TRANSMISSION SEMINAR 1991

TRANSMISSION SEMINAR

Technical Service Information

Figure 1

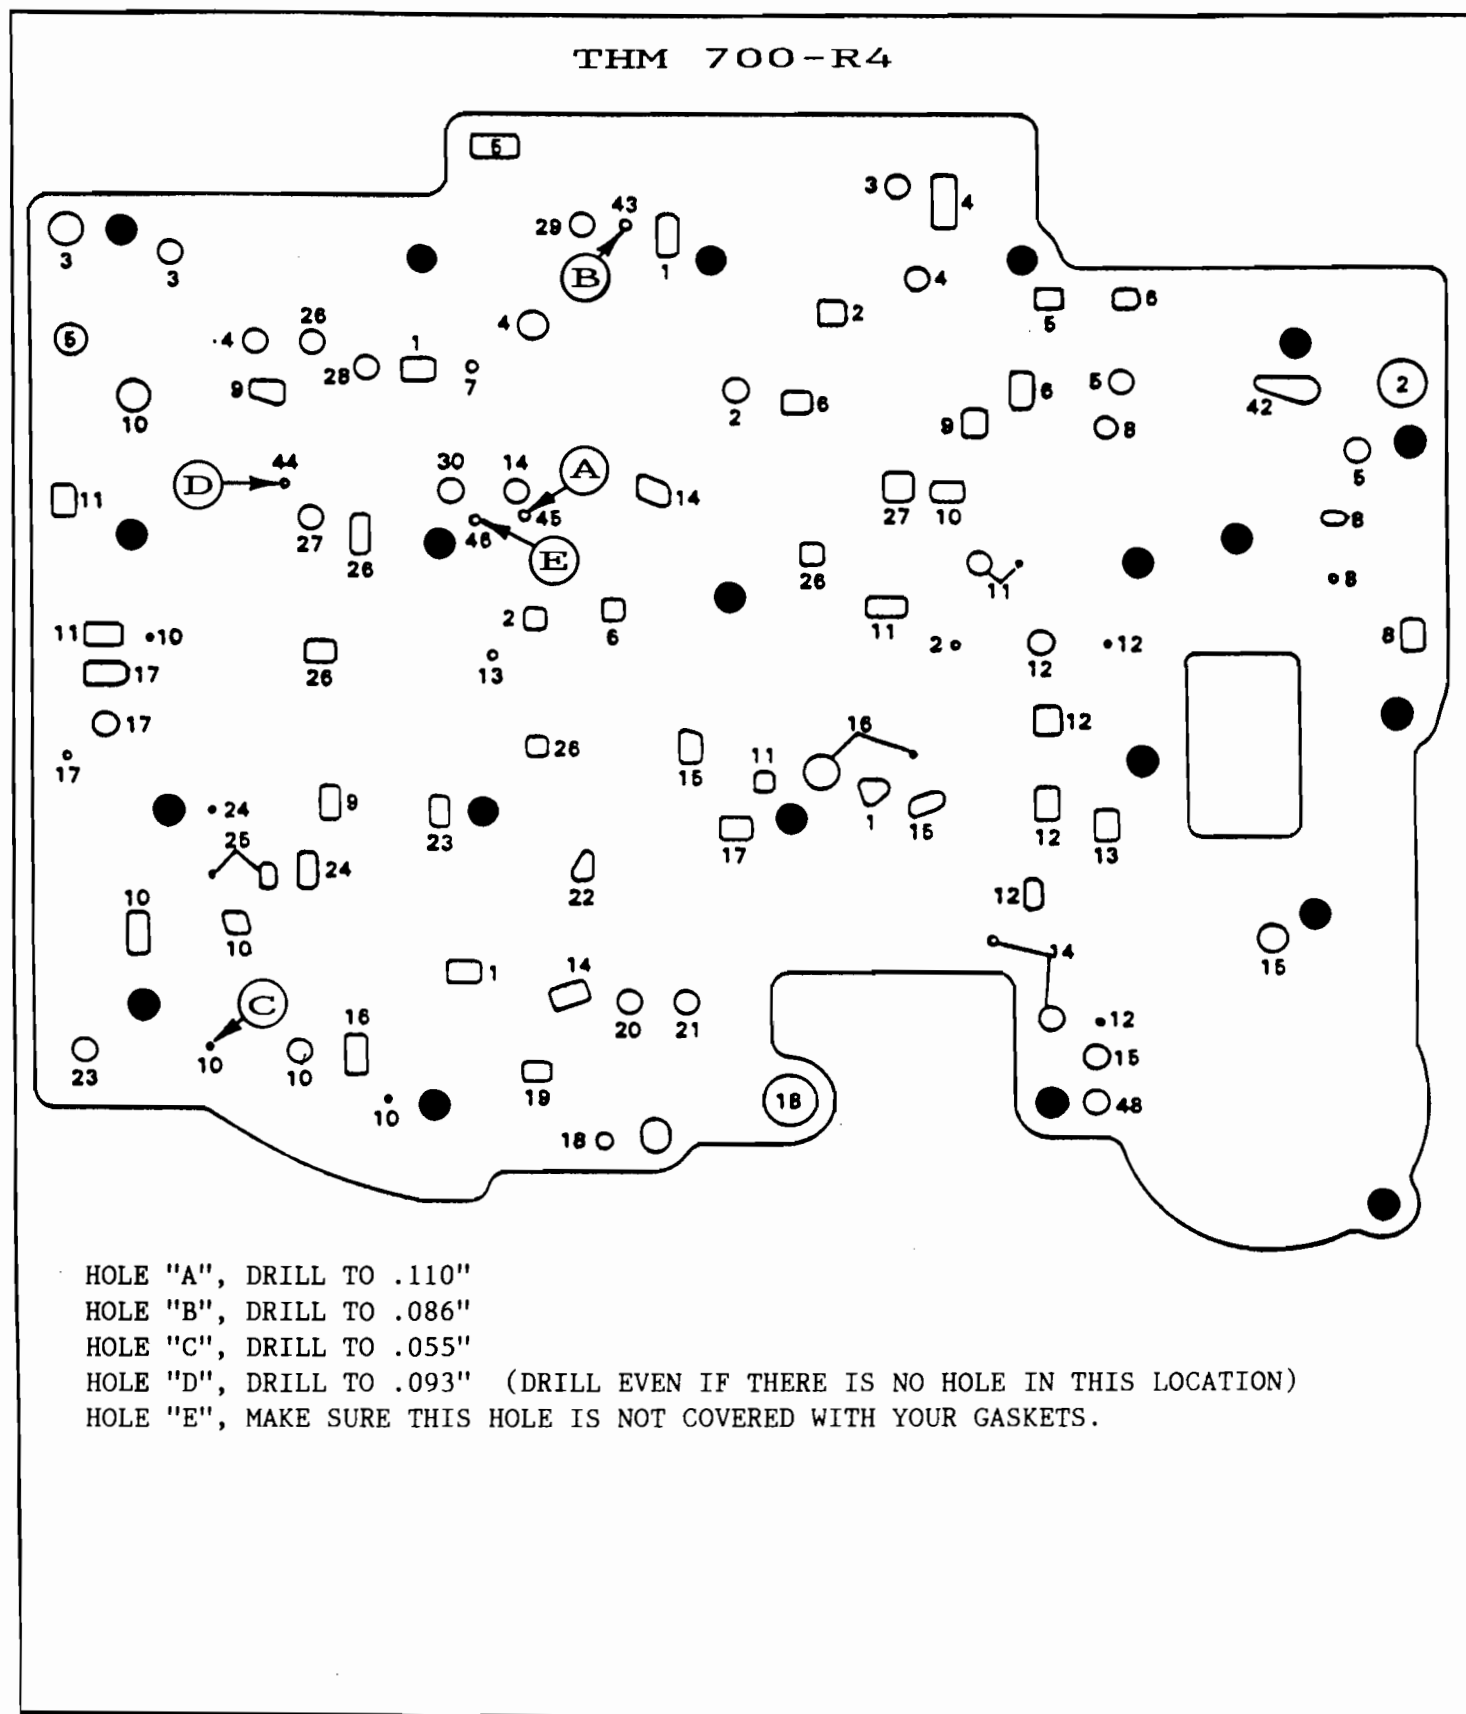
COMPLAINT: Soft and/or mushy upshifts regardless of throttle position.

CAUSE: Not enough feed oil to the 2-4 band, and the 3-4 clutch pack.

CORRECTION: Drill the holes in the spacer plate, as shown in Figure 1, as follows:

HOLE "A", DRILL TO .110".

HOLE "B", DRILL TO .086".

HOLE "C", DRILL TO .055".

HOLE "D", DRILL TO .093".

HOLE "E", MAKE SURE THIS HOLE IS NOT COVERED WITH YOUR GASKETS.

This will improve the 1-2 shift.

This will improve the 2-3 shift. DO NOT drill any larger than .086" as a larger hole will create a flare on the 2-3 shift on some models.

This will prevent the T.V. valve from hydraulically locking.

This will help prevent the 3-4 clutches from burning. This hole was eliminated on the 1988 and later 5.7L models. If your spacer plate does not have this hole, use the gasket as a template and drill it to .093".

Figure 8

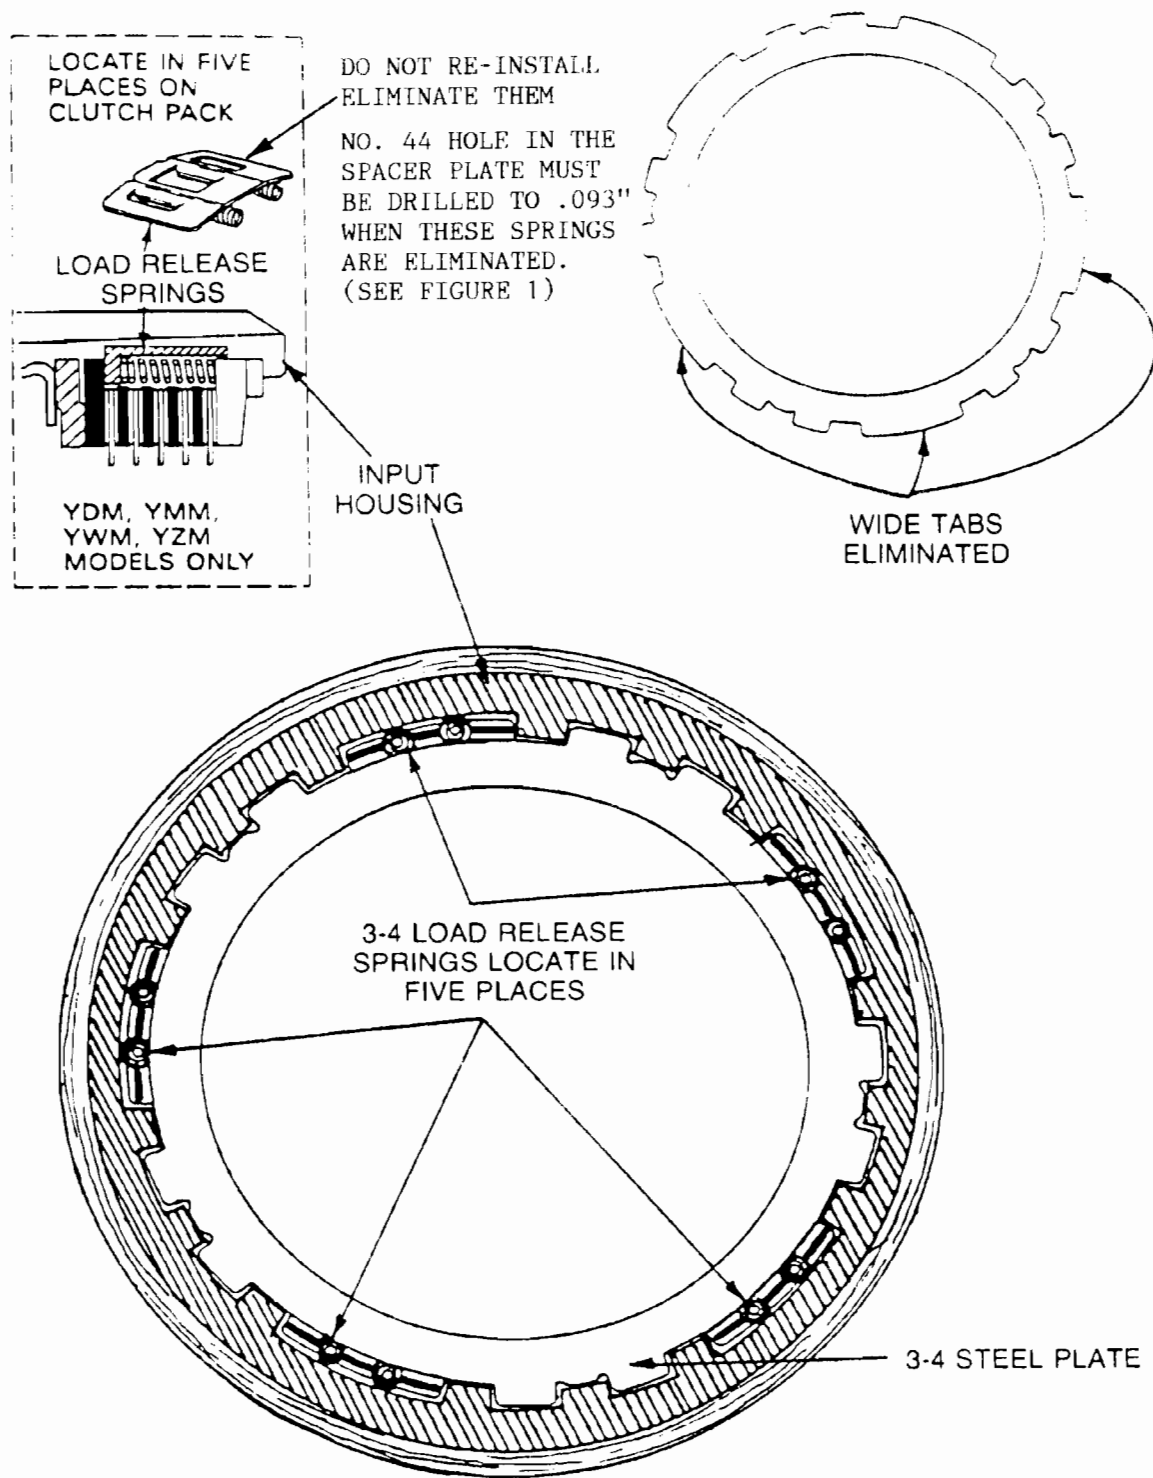
CHANGE: Load Release Springs are added to the 3-4 clutch pack on "F" and "Y" cars only (See Figure 8).

REASON: The load release springs were added to quicken the release of the 3-4 clutch pack on downshifts.

- (1) 3-4 Load Release Springs – Added on YDM, YMM, YWM, and YZM models only, and locates in five places around the 3-4 clutch pack (See Figure 8).
The 3-4 clutch pack now requires some special attention on the stack up. The wide tabs on the 3-4 steel plates were eliminated to make room for the load release springs (Figure 8). However, there is still "One" flat steel plate WITH the wide tabs required in the new 3-4 clutch pack. It goes on top of the stepped apply plate, and provides a "Seat" for the 3-4 load release springs (See Figure 8).

Should not be used on any models previous to 1988, nor on any 1988 model, other than models listed above.

Figure 9

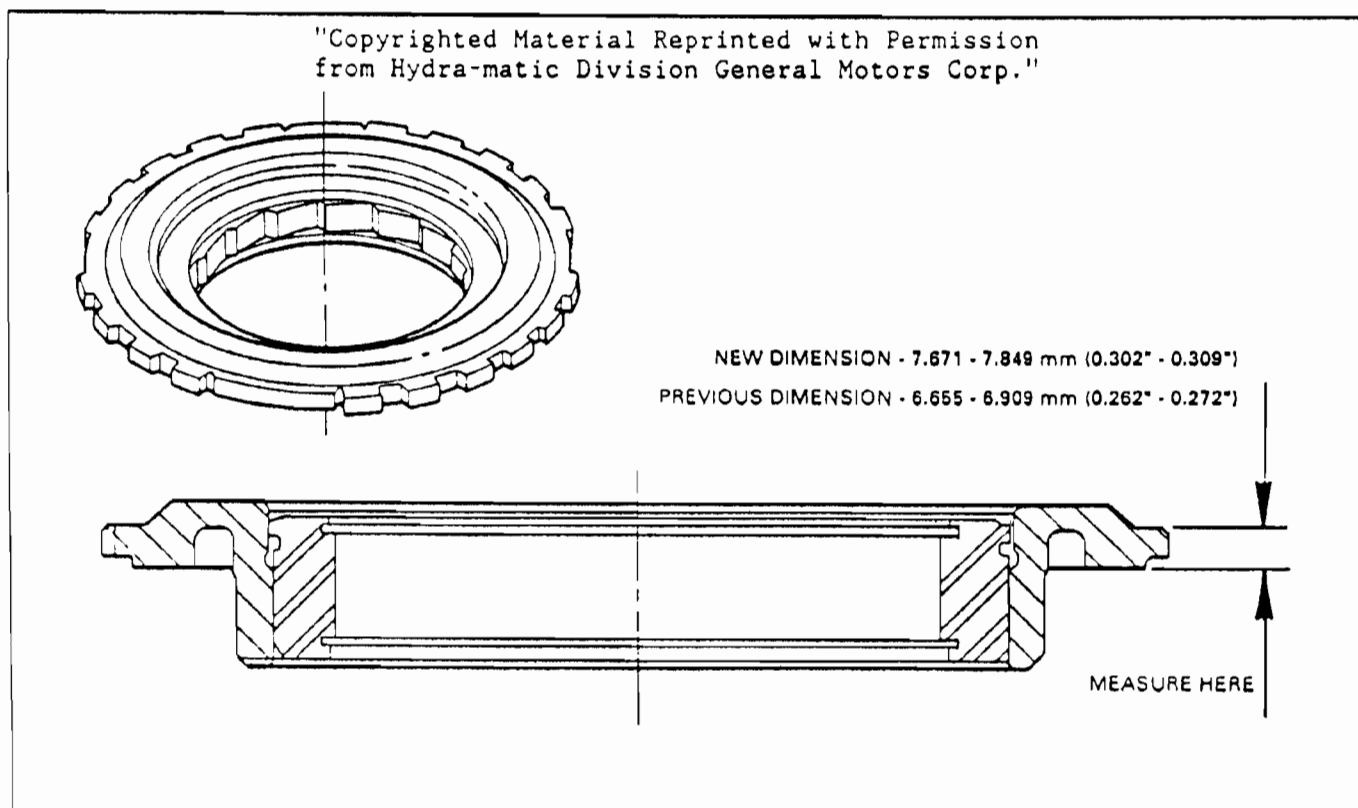
Beginning on November 1, 1989 (Julian Date 305) on all 1990 model THM 700-R4 transmissions, a new Low/Reverse Clutch Support went into production, that was made thicker. The "ONLY" way to identify the new low/reverse clutch support is to measure its thickness with a micrometer (See Figure 9).

Figure 12

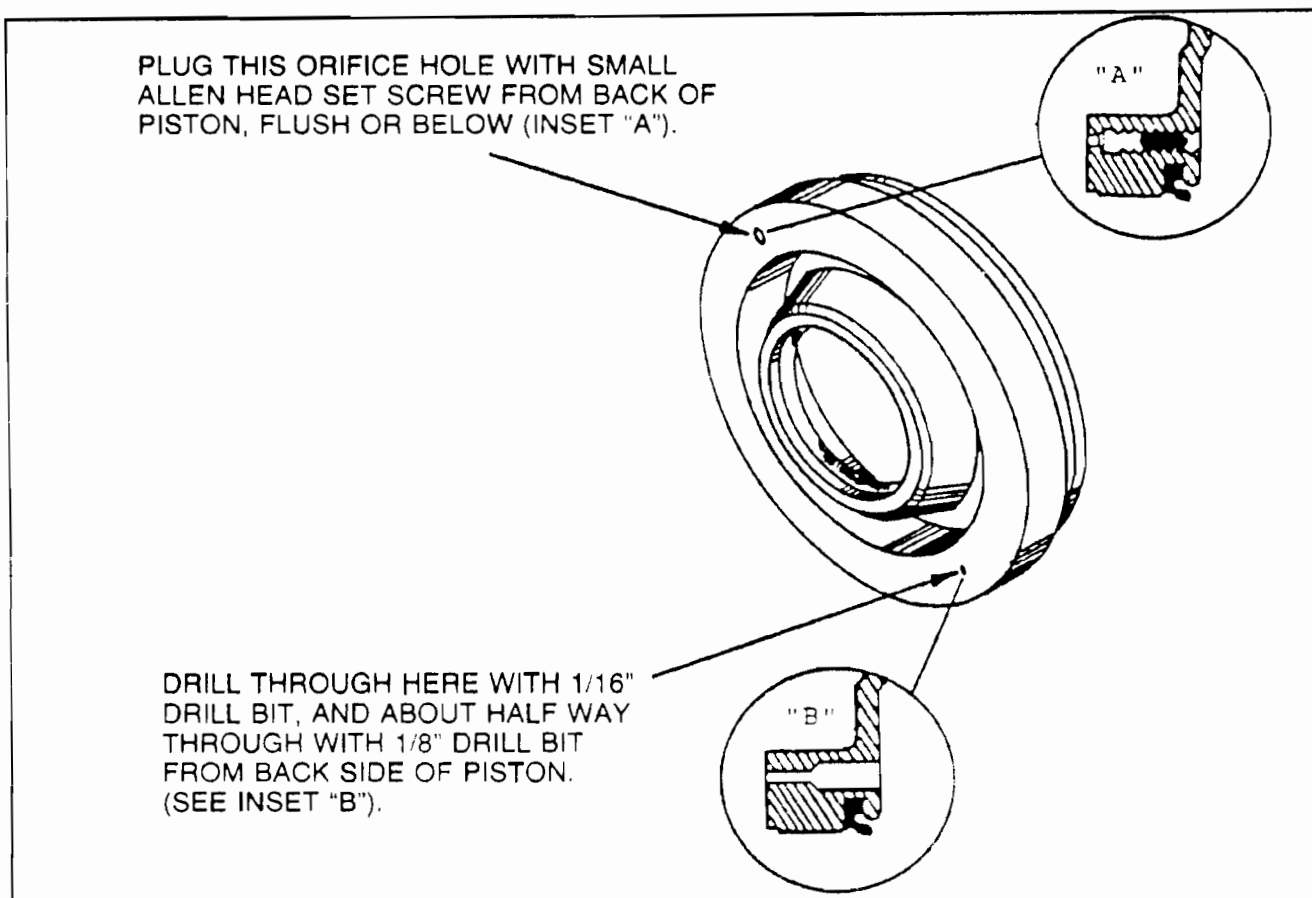
- COMPLAINT:** Premature failure of the reverse input clutches, on 1987 or later models only. These models have the new aluminum piston.
- CAUSE:** The cause may be the orifice hole in the new aluminum piston being larger than the feed hole in the reverse input housing. The original orifice hole was .116".

- CORRECTION:** This should be modified on ALL aluminum pistons to eliminate any repeat failures, and there are two methods.
- METHOD NO. 1.**
Plug the original hole from the back side of piston with an allen head set screw, flush or below. Retain the set screw with Loc-tite, (See Figure 12, Inset "A").
180 degrees from original hole you will find a hole started but not drilled through. Drill through here with a 1/16" drill bit, from the front side of piston. Turn the piston over and from the back side of piston, drill about half way through with a 1/8" drill bit (See Figure 12, Inset "B"). Please use a drill press for this operation to keep the holes straight.

- METHOD NO. 2.**
Install an orifice cup plug, OEM part number 8631146, into original hole from the back side of piston, and enlarge orifice to 1/16".

Figure 14

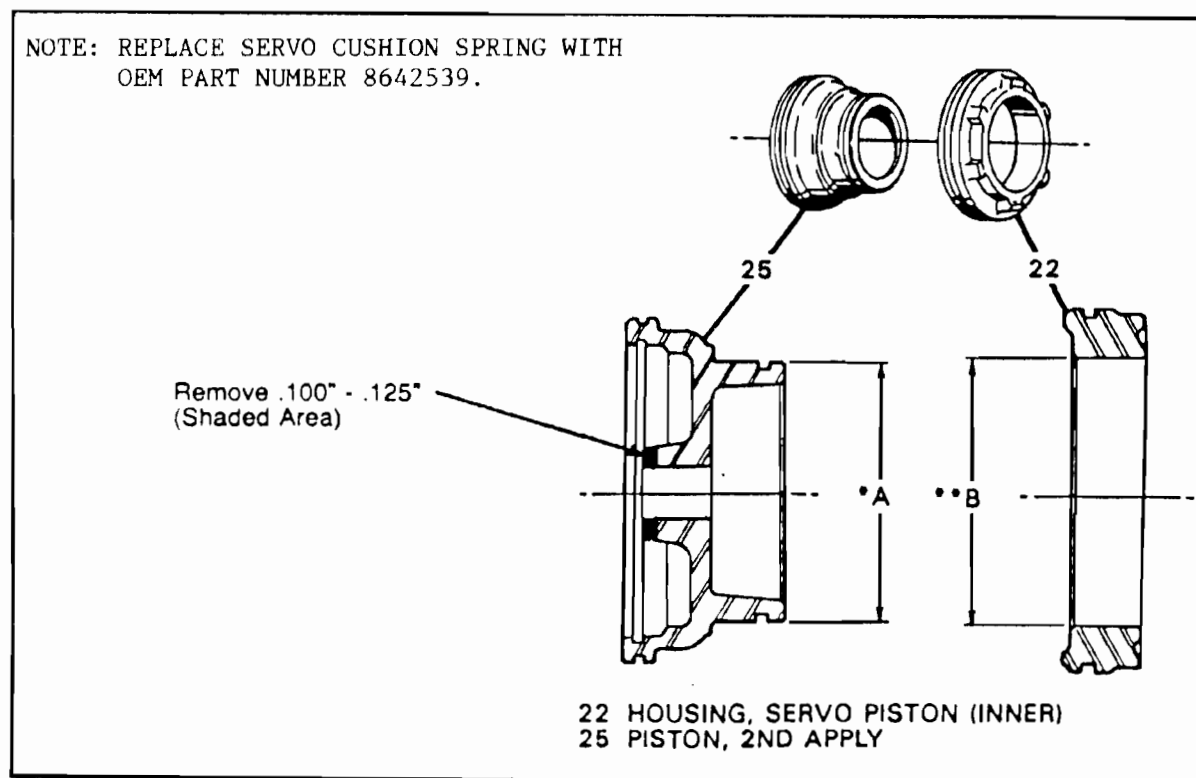
COMPLAINT: Severe "Clunk" on a coastdown 3-2 shift, in the D3 range only. The noise is more noticeable if the vehicle is heavily loaded or towing a trailer.

CAUSE: Not enough travel for the 2/4 servo cushion spring.

CORRECTION: Remove .100" to .125" from the inner hub of the 2nd apply servo piston as shown in Figure 14, and replace the servo cushion spring with OEM Part Number 8642539.

Figure 15

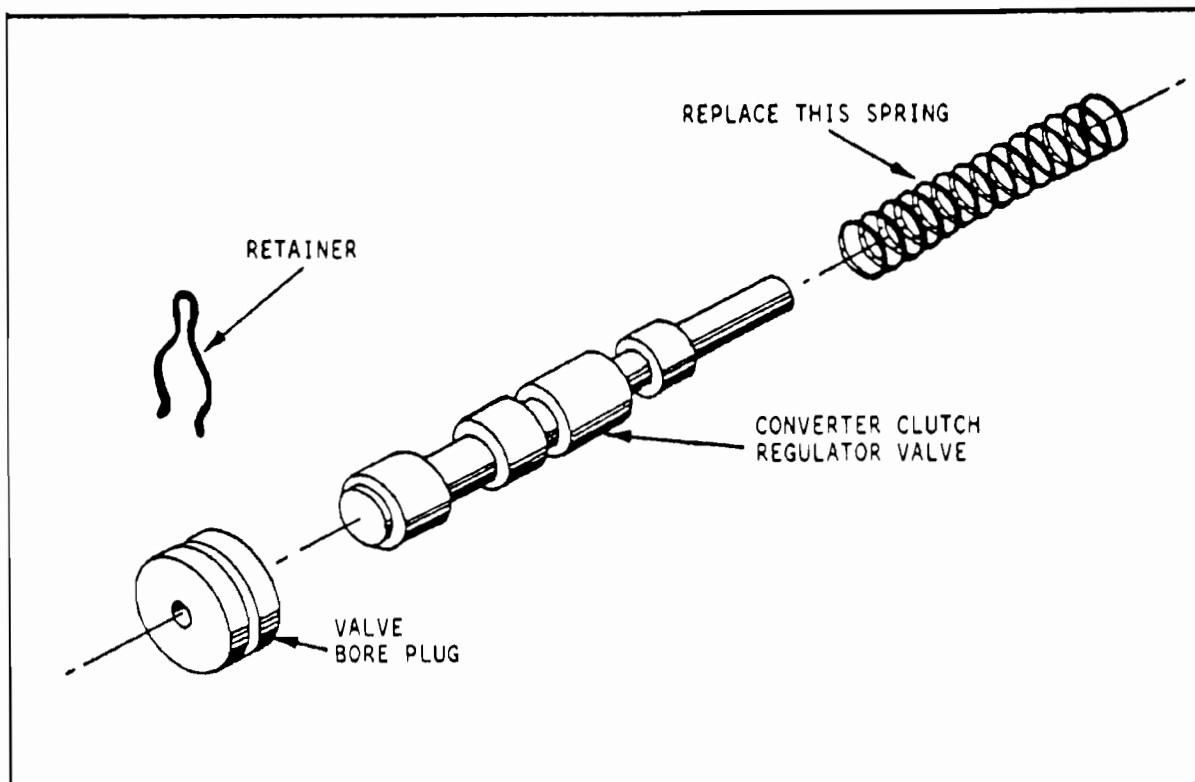
COMPLAINT: Converter clutch shudder on any THM 440-T4.

CORRECTION: There is now available from the aftermarket suppliers a spring for the converter clutch regulator valve that will raise the apply pressure from 45 PSI to 61 PSI, and will eliminate converter clutch shudder (See Figure 15).

The new spring is available under part number SGSF-440.

Figure 21

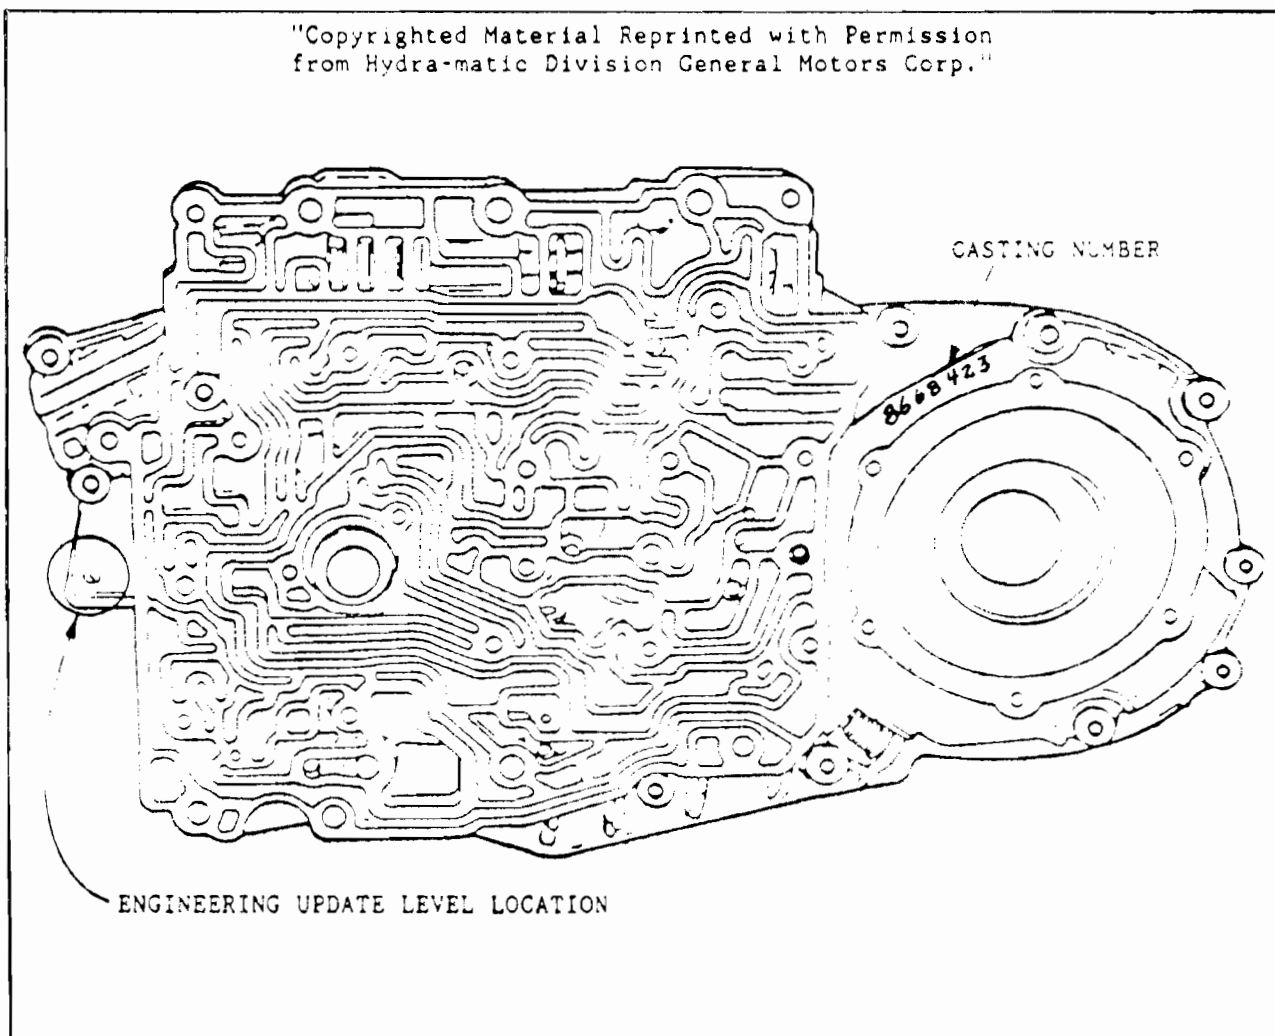
This was created by a change in the channel plate porting, in the manual valve area. The questionable channel plate can be identified by the casting number "8668423", with engineering update level "E". Refer to Figure 21 for locations. Casting number "8668423" with engineering update levels "A", "B", "C", and "D" are OK to use.

DO NOT USE CASTING NO. "8668423" WITH ENGINEERING UPDATE LEVEL OF "E" OR HIGHER - REFER TO FIGURE 21 FOR LOCATIONS OF BOTH.

CORRECTION: Install an earlier model channel plate that does not have the questionable casting number 8668423, as long as it is 85 1/2 or later channel plate.
